**Re: DEP School House Rd. HDD Re-Evaluation Report - Request for Additional Information
School House Road Crossing 16" Horizontal Directional Drill (S3-0091-16)
Permit No. E38-194
South Londonderry Township, Lebanon County**

In compliance with the Corrected Stipulated Order dated August 10, 2017, a Re-Evaluation Report on the above-referenced horizontal directional drill (HDD) was submitted to the Department on February 20, 2019. In a letter dated March 28, 2019, the Department requested further information to which SPLP responded on May 21, 2019. On July 24, 2019 the Department emailed a list of four (4) items commenting on SPLP's May 21st response, or requesting additional information. Please accept this letter as a response to those emailed items. Your comments or requests are bolded below followed by Sunoco Pipeline, LP (SPLP) responses.

DWG. NO: PA-LE-0005.0000-RD-16

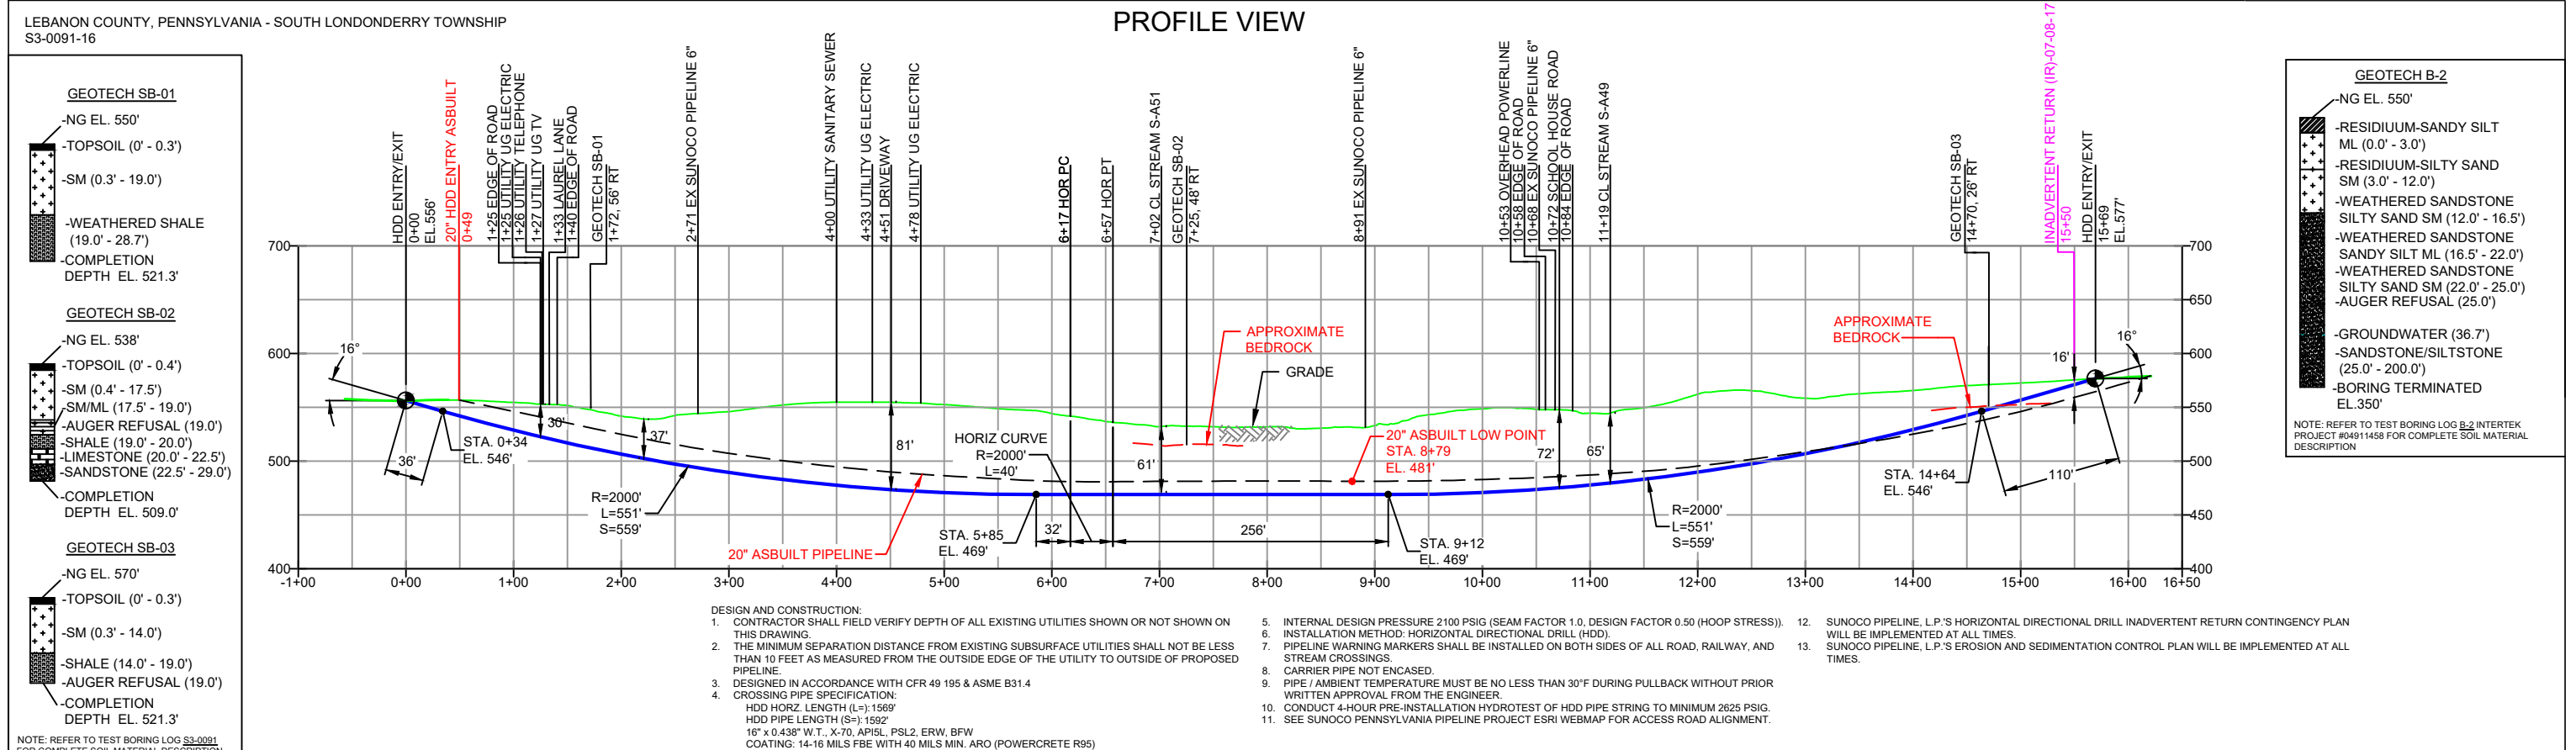
2. The third paragraph on Page 2, last sentence states: "... maximizing the entry/exit angles, which has been done on the revised HDD profile." Provide DEP with the revised figure that demonstrates these new maximized entry/exit angles for the HDD profile.

Upon review, it appears that the pdf file for the revised profile was corrupted when it was inserted into the Re-Evaluation Report. The revised HDD profile illustrating the 16 degree entry and exit angles is attached to this response.
